SUBJECT: Duke Energy Carolinas, LLC  
Catawba Nuclear Station Units 1 and 2  
Docket Nos.: 50-413 and 50-414  
Emergency Plan, Revision 16-1

Subject: Catawba Nuclear Station Emergency Plan  
Revision 16-1

**Catawba Nuclear Station  
Emergency Plan Revision 16-1  
Attachment 1  
10CFR50.54(q) Evaluation**

**FIGURE H-2**  
**DUKE ENERGY**  
**Catawba Nuclear Site Operations Support Center**

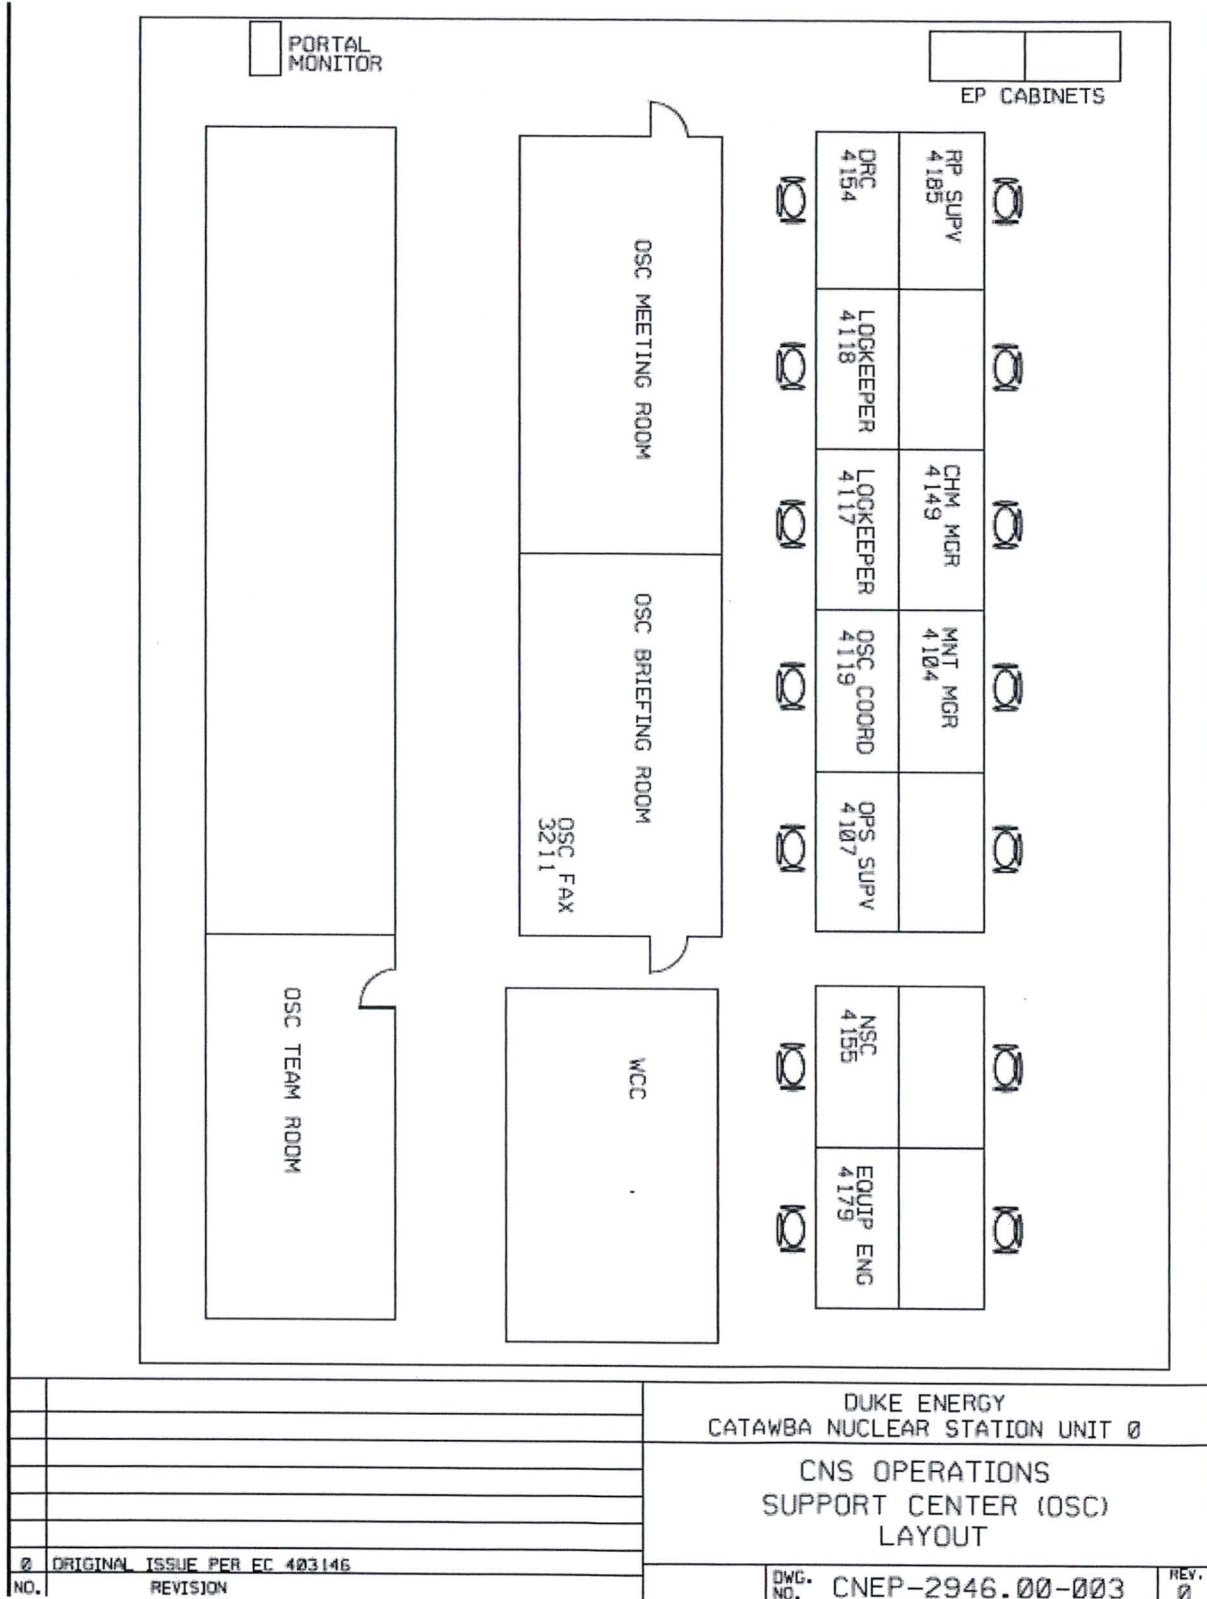
Updated figure H-1 Technical Support Center (TSC), H-2 Operations Support Center (OSC), and H-7 Joint information Center (JIC) to represent current layout as a result of remodeling facilities.

A change is being made to section H which describes the Emergency Facilities and Equipment used by the CNS Emergency Response Organization. Figure H-1 Technical Support Center (TSC), H-2 Operations Support Center (OSC), and H-7 Joint Information Center (JIC) are being updated to represent current facility layout. These facilities were remodeled to improve use and incorporate new technology. The remodeling did not change the function of the facilities or location. This change continues to designate the points of contact and physical locations for use by news media during an emergency and continues to ensure adequate facilities are maintained to support emergency response.
